寄件者: Tang Lok San <[REDACTED]>
寄件日期: 2026年08月11日星期二 15:02
收件者: tpbpd/PLAND
副本: Ivan Sze Yuet FUNG/PLAND
主旨: Re: S. 16 Planning Application No. A/YL-KTN/1257 - Departmental Comments
附件: AYL-KTN 1257 20260811.pdf

有關環境保護署對 A/YL-KTN/1257 的查詢

有關對古物古蹟辦事處 A/YL-KTN/1257 的查詢

Responses on DSD's Requirements / Reminders

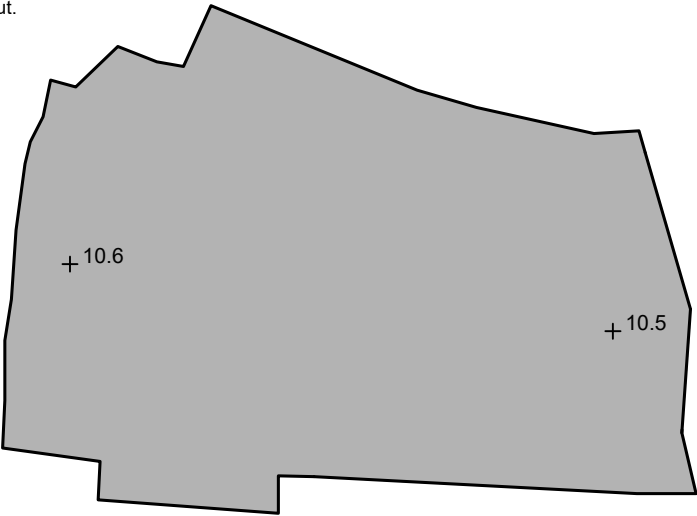
收悉 貴處對 A/YL-KTN/1257 申請的疑問，本人現書面回覆：

填土及平整方面，本申請之填土及平整的範圍請參考 **Appendix 4**。不會將整個申請範圍填到相同或相約的水平高度，會保留現有的地型。

填土及平整物料方面，申請地點現時已使用混凝土填高及平整約 **0.2** 米。申請人會在申請結束後根據規劃署及地政總署的要求將鋪地的物料打碎並運走，回復原來面貌，不會為該地造成長遠影響。
